Addendum

Project Name:	Kariong Sand and Soil Supplies - Air Quality Assessment – RTS
Reference:	18.1021.L2V4

The following letter has been prepared by Northstar Air Quality Pty Ltd on behalf of Jackson Environment and Planning Pty Ltd and provides a response to submissions (RTS) associated with the Air Quality Impact Assessment (AQIA) which was prepared to support the Kariong Sand and Soil Supplies EIS (SSD 8660).

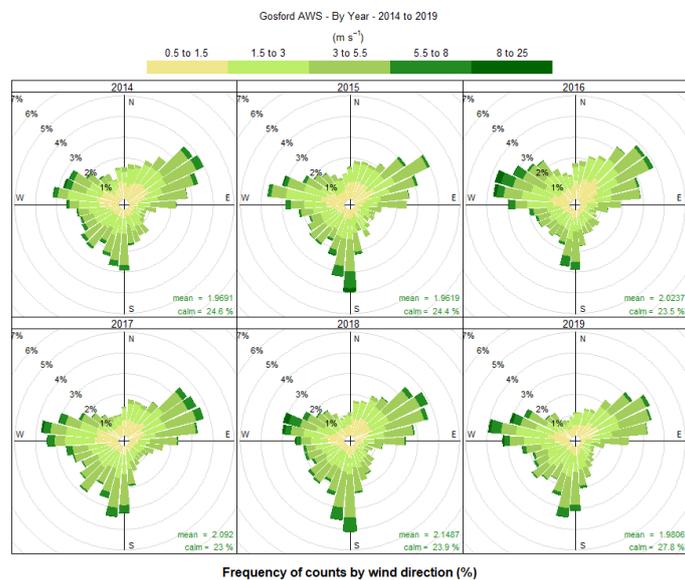
“The previous AQIA (V1 2019) included discussion of 2 approaches used for meteorological modelling using TAPM. Neither approach provided an adequate representation of the local meteorology when the output data were compared to observations at the Gosford AWS (data validation).

The revised AQIA (V2, 2020) includes results of additional meteorological modelling (approach #3) which was performed using WRF meteorological model output as input to CALMET. This approach again, did not adequately characterise the observed wind conditions.

A fourth approach has been performed using AERMOD. Observational data from Gosford AWS has been adopted as an input to the dispersion model. As such, the predicted wind roses closely resemble those at Gosford Automatic Weather Station.

Furthermore, the meteorological analysis undertaken has only considered 3 consecutive years of data (2014 to 2016), rather than the 5 years recommended in the Approved Methods for the Modelling and Assessment of Air Pollutants in NSW (2016). No justification for this shorter review period was provided. This further increases the uncertainty associated with the AQIA (V2, 2020).

The EPA notes there is still uncertainty associated with the meteorological modelling undertaken in the AQIA (V2, 2020). However, the uncertainties could be adequately managed via a commitment to improved engineering controls including fully enclosed structures around processing areas.”

Meteorological monitoring commenced at Gosford AWS in 2013 and therefore data for full calendar years were available from 2014 to 2016 at the time of the assessment being performed. More recent data has been examined (2017 to 2019) with those wind roses presented below. These indicate that the selection of the modelling year of 2015 is valid and entirely appropriate. There is little inter-annual variability in the meteorological observations and the selection of any of the years 2014 to 2019 would have made little material difference to the results of the assessment.

As previously discussed, the proponent has committed to included full enclosure of materials processing activities.

Dispersion modelling has also been re-performed to include a number of adjustments as previously noted, and compliance with the NSW EPA air quality criteria is still achieved (refer **Appendix B**).

As previously discussed, the proponent will also install a meteorological monitoring station at the site, with site-specific data used in any updated air quality modelling assessment to remove any uncertainty associated with those inputs.
